New Opening Date, Clarifications to the Specifications and

Bid Item #23-187 Augusta Regional Airport Gates 3 and 4 Terminal

ADDENDUM NO. 1

DO NOT SCALE DRAWINGS SHEET CONTENTS FIRST FLOOR FURNITURE PLAN

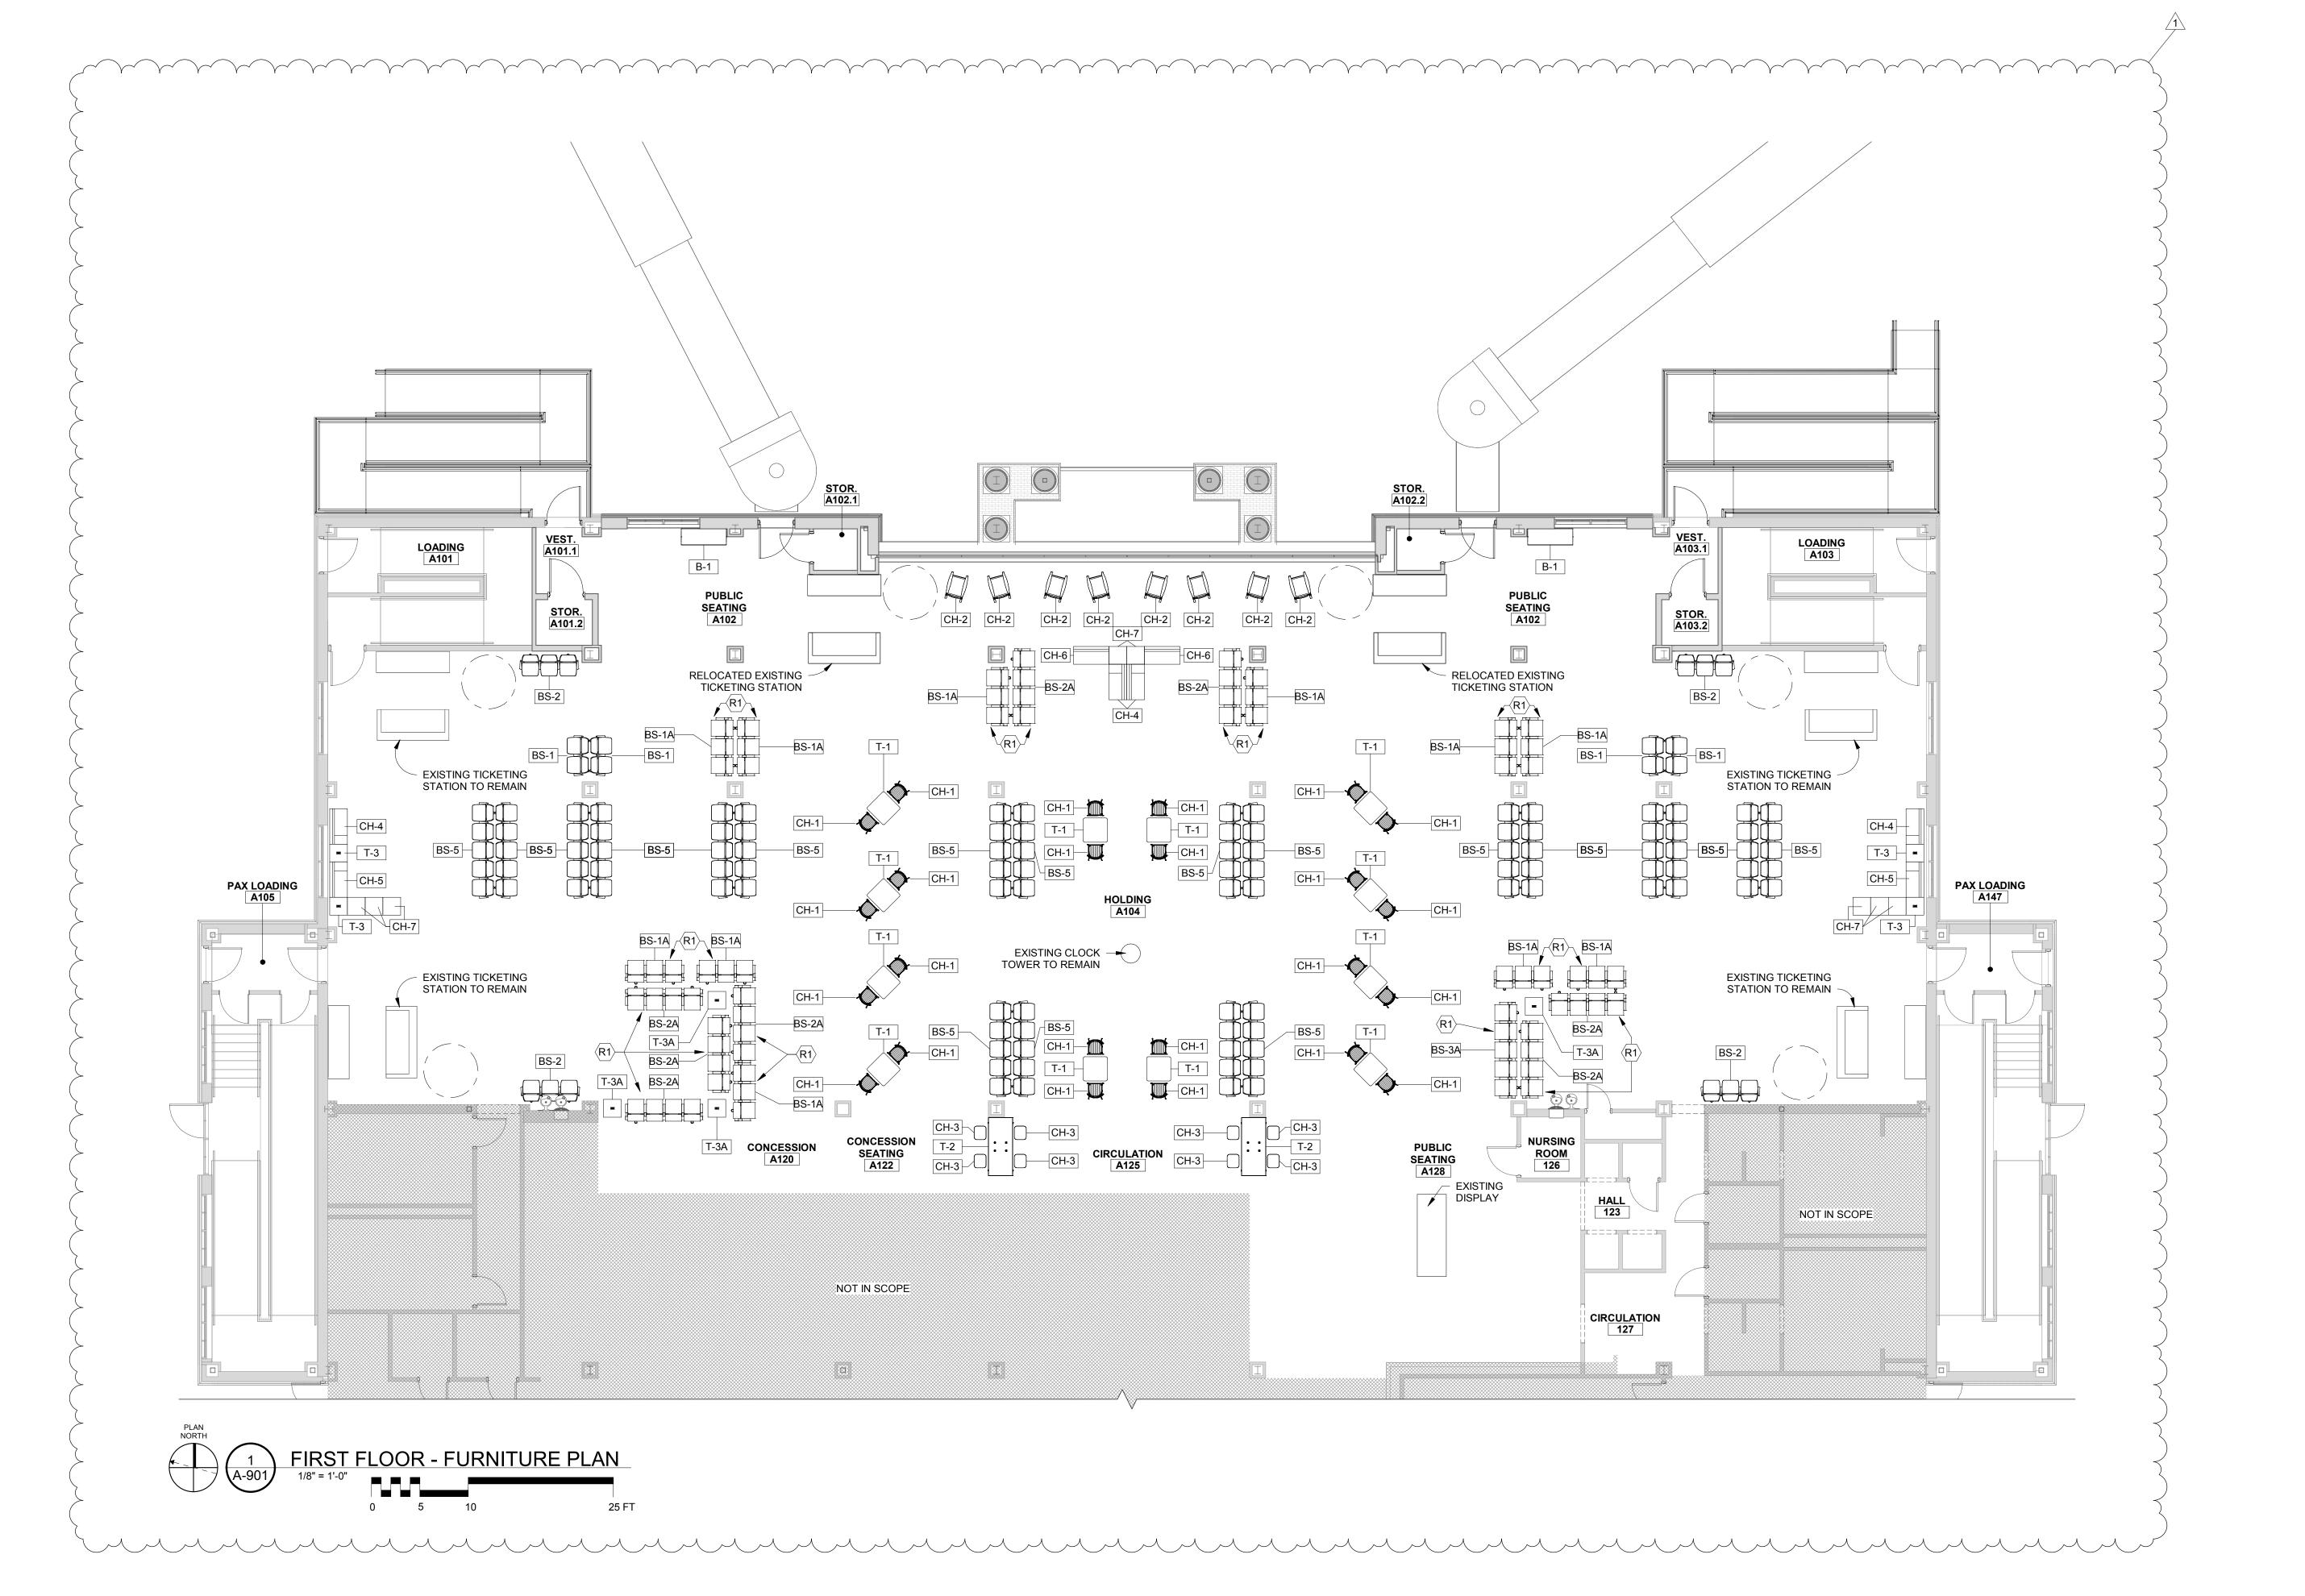
- a. Elevation Detail 1 add alternate #1 note.
 - b. Elevation Detail 2 add alternate #1 note.
 - c. Elevation Detail 3 add alternate #1 note.
- 9. Replace Sheet A-901 First Floor Furniture Plan with Revised Sheet A-901 First Floor Furniture Plan herein attached. Revisions include:

- a. Updated furniture plan.
- 10. Replace Sheet E-121 Lighting Plan with Revised Sheet E-121 Lighting Plan herein attached. Revisions include:
 - a. Update plan and notes for wall sconces scope.

G-031

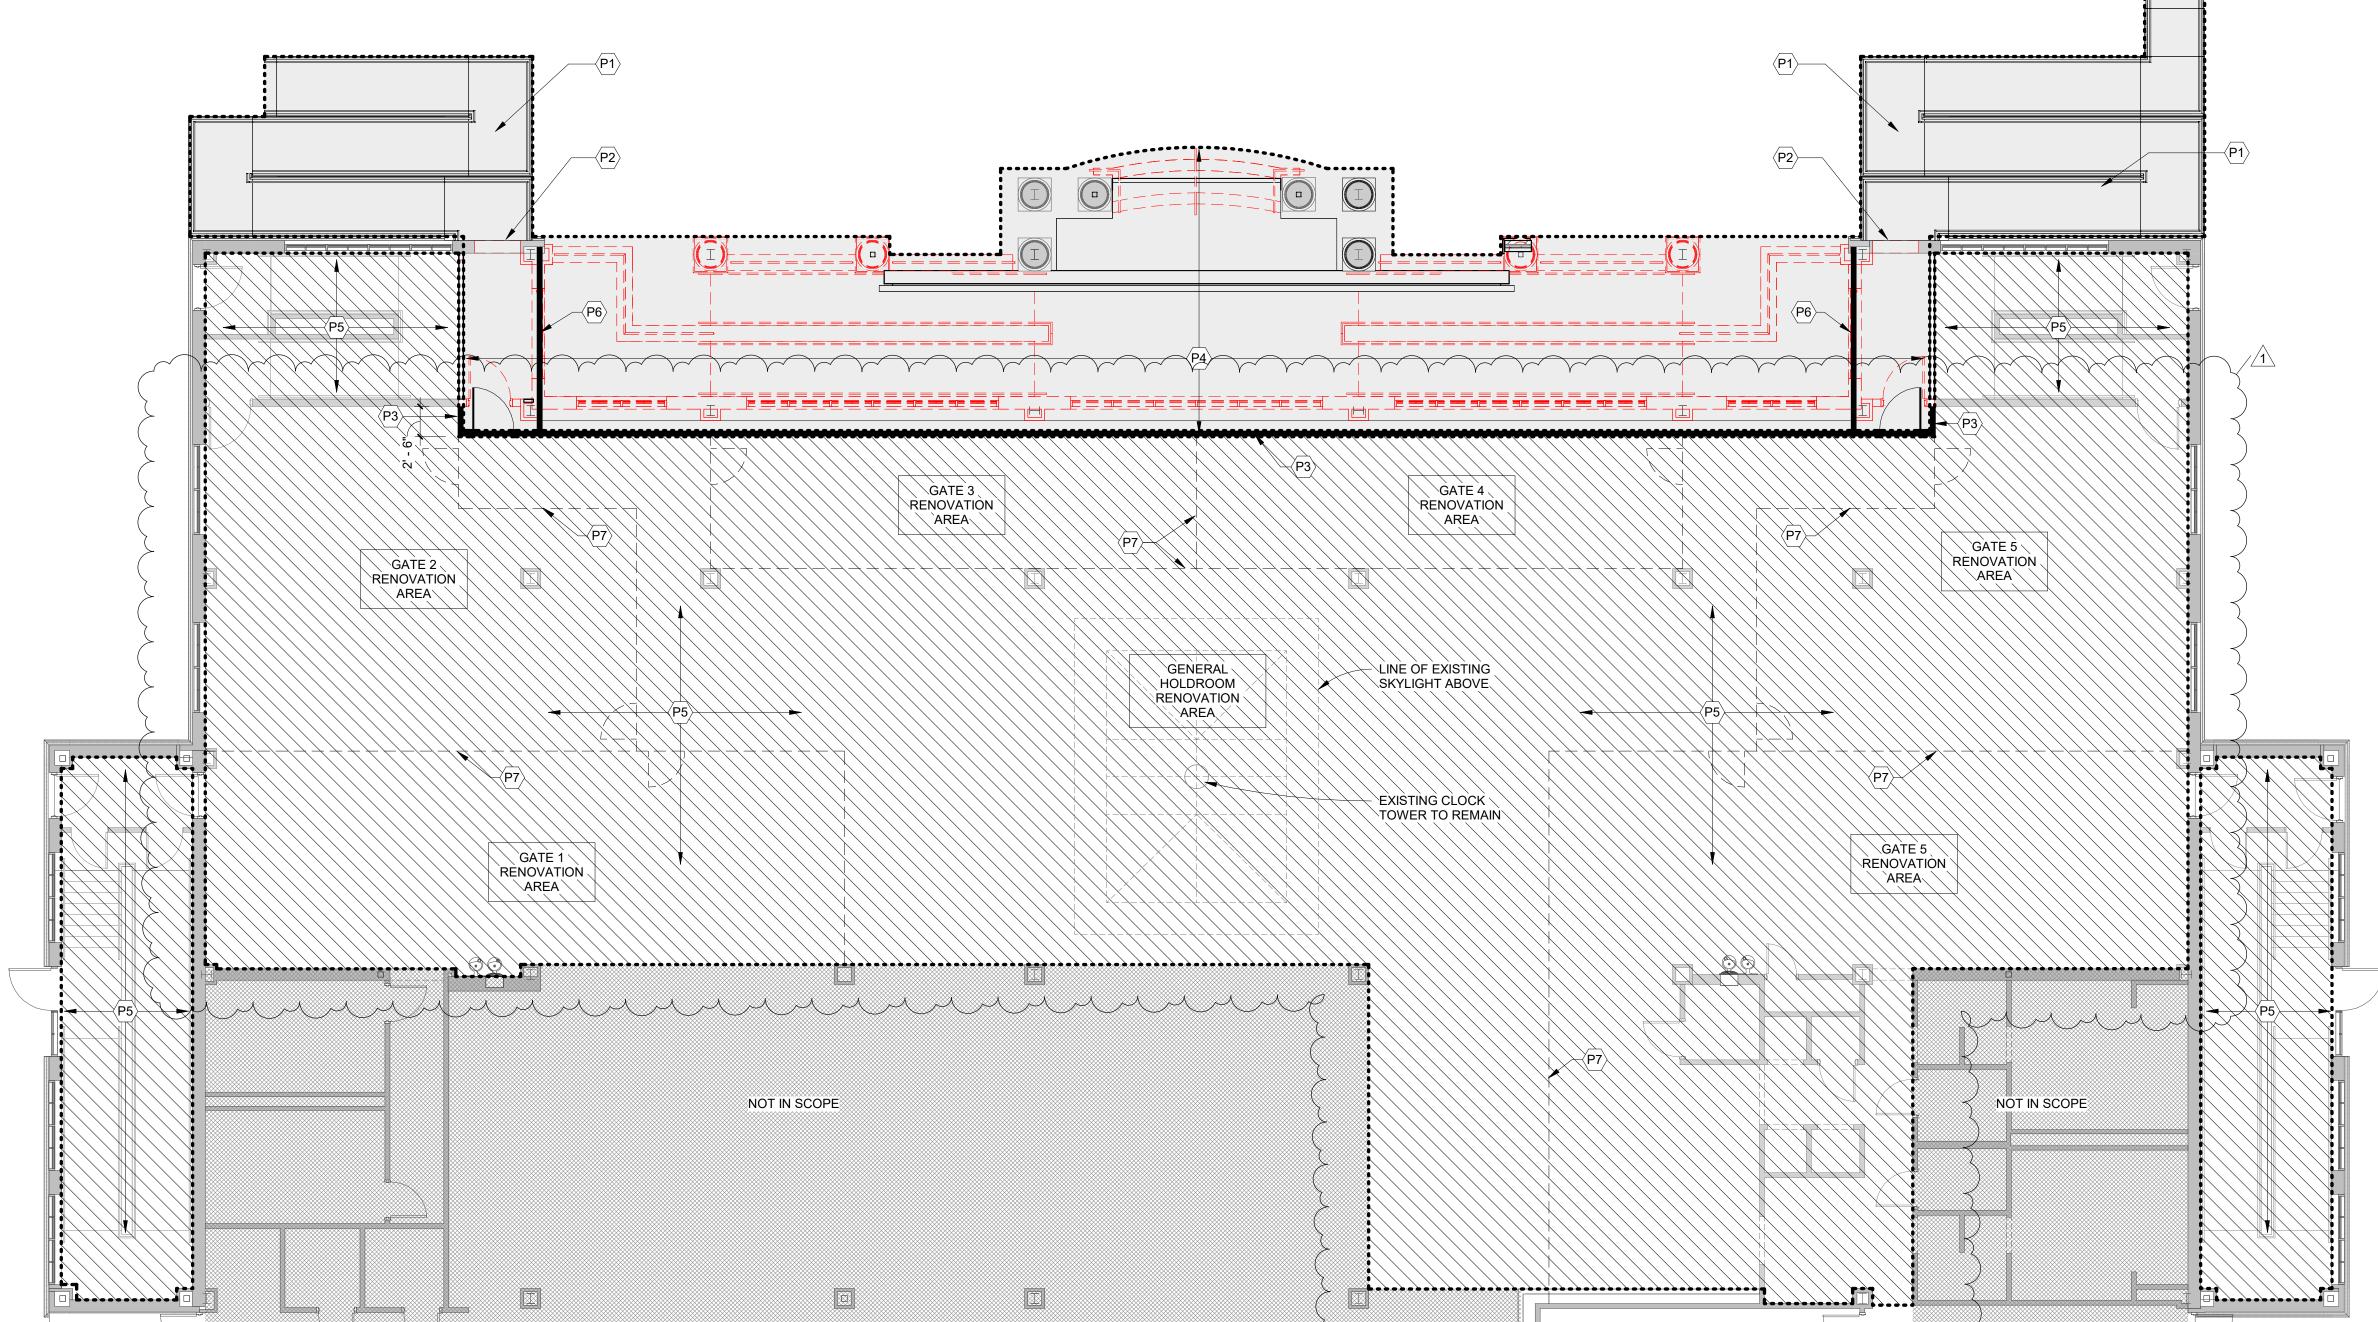
- 1. Sheet S-001 Structural Notes
 - a. Revise Structural Design Criteria, Note 8 to read "Net Allowable Soil Bearing Pressure 2,000 PSF"
- 2. Replace Sheet G-031 Construction Phase Plan with Revised Sheet G-031 Construction Phasing Plan herein attached. Revisions include:

- a. Revised Plan 1 / G-031 First Floor Phasing Plan.
 - b. Revised Details 2 / G-031 Typical Temporary Construction Wall (Plan, Elevation, and Sections).

- c. Revised Phasing Plan Keynotes.
 - d. Revised Phasing Plan Legend.
 - e. Added General Note 3.
- 3. Replace Sheet A-131 First Floor Reflected Ceiling Plan with Revised Sheet A-131 First Floor Reflected Ceiling Plan herein attached. Revisions include:
